Site No: 10404

School: Hereward Primary School

Location: Colebrook Lane, Loughton

View of site facing Hereward Green

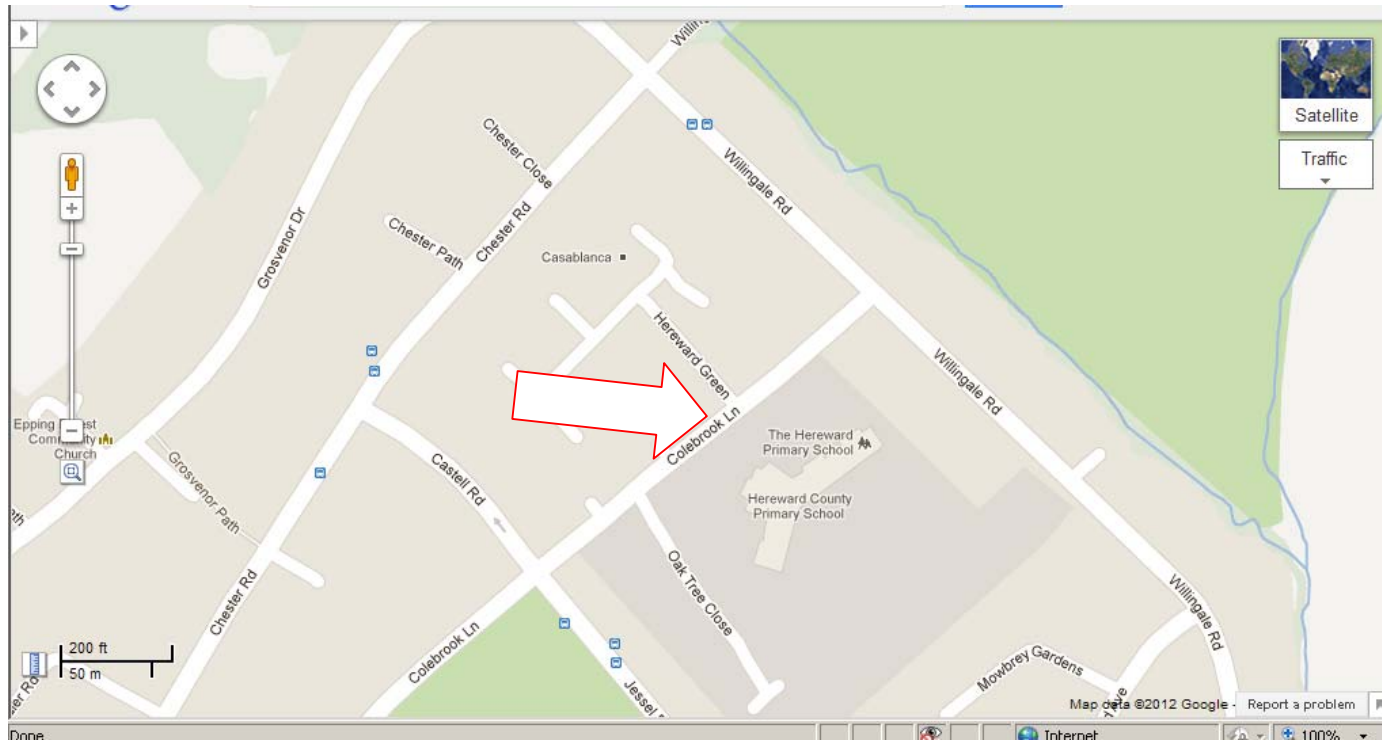
There is a problem with parking close to the patrol site and on the radius of Hereward Green/Colebrook Lane, with vehicles often parking with wheels on the footway. This causes obstruction to the patrol and pedestrians, and reduces visibility for the patrol and of the patrol site.

We would like to request double yellow lines at the radius of the junction with Hereward Green (junction protection) to prevent parking on the corner and timed parking restrictions on the north bound approach on the opposite side from the school to increase visibility of the patrol site.

The photo below shows how vehicles park on the pavement/junction

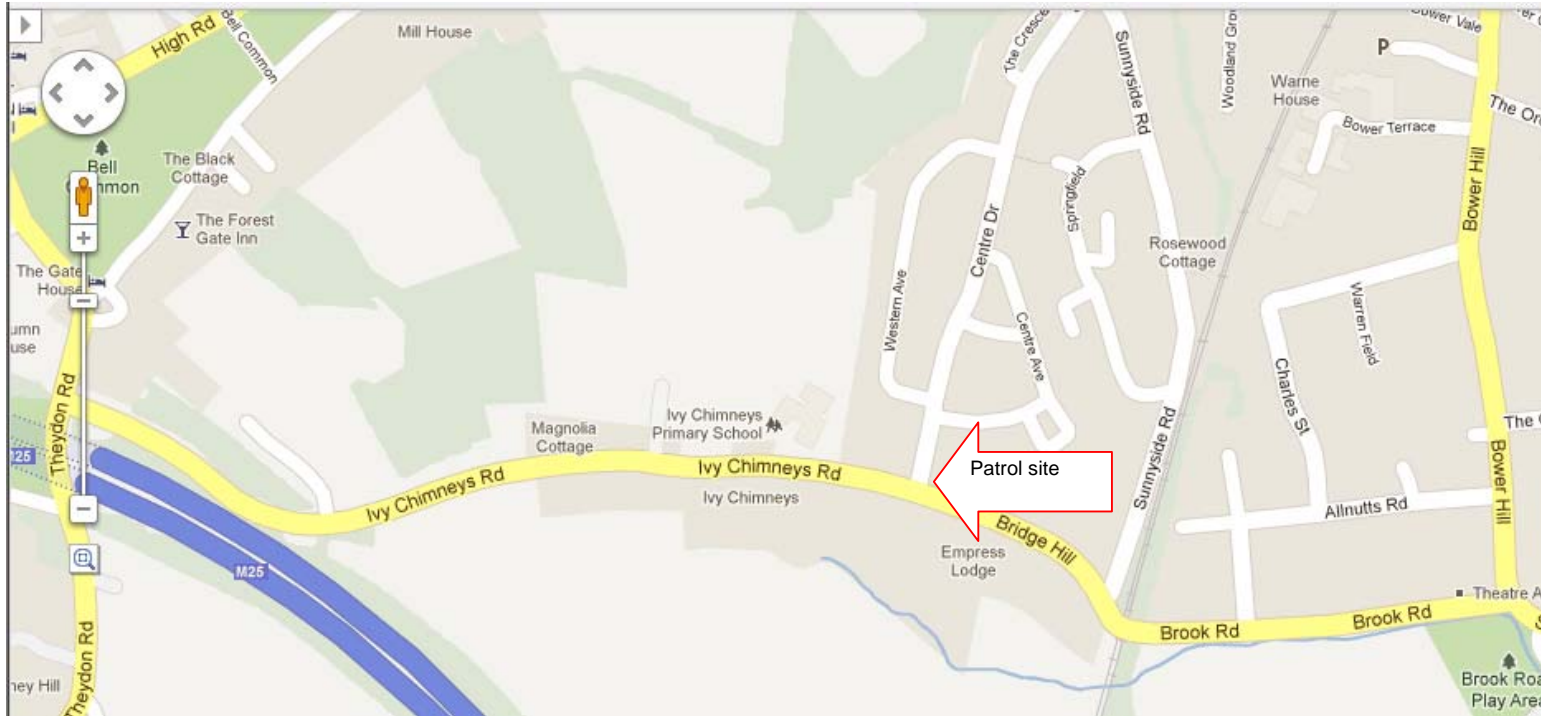
There are existing double yellow lines at the radius of Centre Drive, and single yellow lines (timed M-F 10-11am) that start within 5m of patrol site and vehicles park as close as possible to the site, restricting visibility of patrol.

We would like to request an alteration to the timing of the parking restrictions to keep the area in the vicinity of the site clear during the hours of patrol operation or increase the double yellow lines. This would increase the visibility of the patrol site and discourage inconsiderate parking on the footway.
